# TECHNICAL BULLETIN

No: P045  
Issue: 1  
Date: 22 July 2008

**SECTION: 501**

## RECALL: Rotary Coupler Wiring Fracture

Figure 1

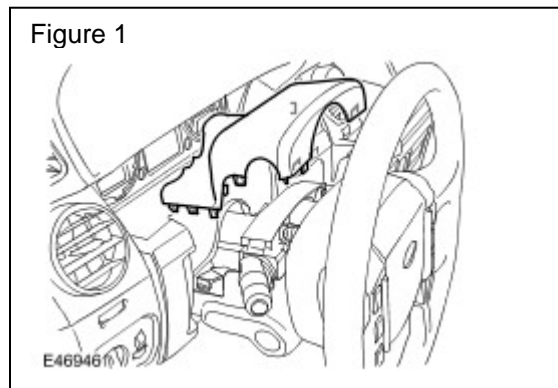
3. Disconnect negative and positive battery cables.
4. Wait two minutes for the SRS power circuit to discharge.
5. Release the six clips to remove the steering column upper shroud. (Figure 1)

Figure 2

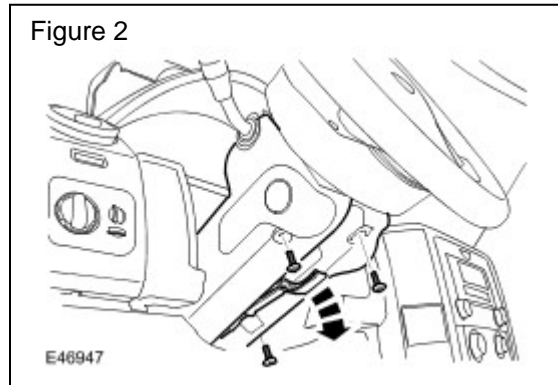
6. Remove the three Torx screws to remove the steering column lower shroud. (Figure 2)
7. Insert ignition key and turn to position 1.

Figure 8

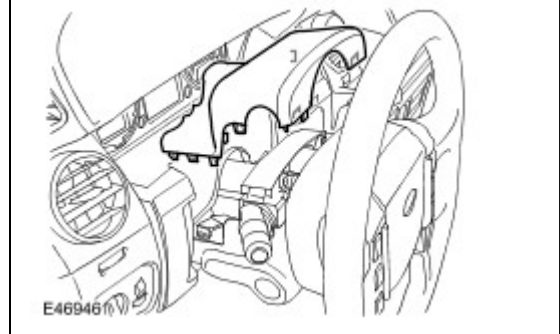
3. Disconnect negative and positive battery cables.
4. Wait two minutes for the SRS power circuit to discharge.
5. Release the six clips to remove the steering column upper shroud. (Figure 8)
6. Remove the three Torx screws to remove the steering column lower shroud. (Figure 9)
7. Insert ignition key and turn to position 1.

Figure 10

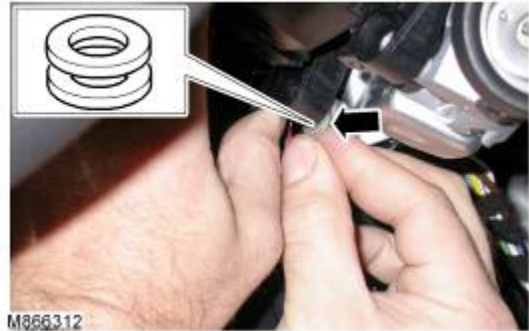
8. Rotate steering wheel for access as necessary.
9. Remove and discard the multi-function switch assembly's fourth fixing M5 x 14mm long screw (FYP500250). (Figure 10)

Figure 14

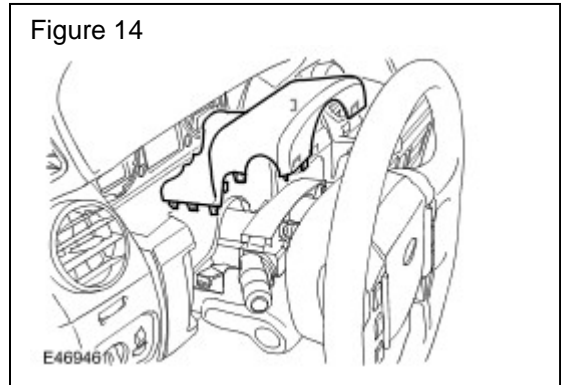
1. Fully extend the steering column for access.
2. Release the six clips to remove the steering column upper shroud. (Figure 14)

Figure 15

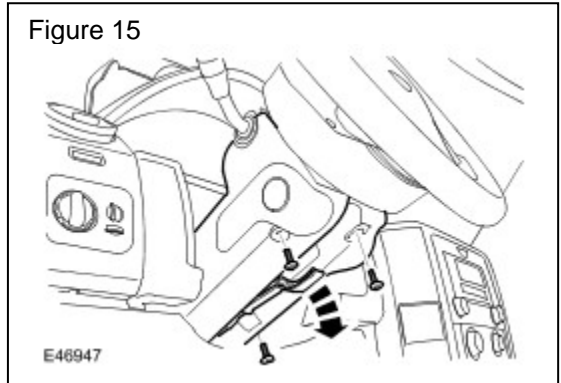
3. Remove the three Torx screws to remove the steering column lower shroud. (Figure 15)
4. Insert ignition key and turn to position 1.
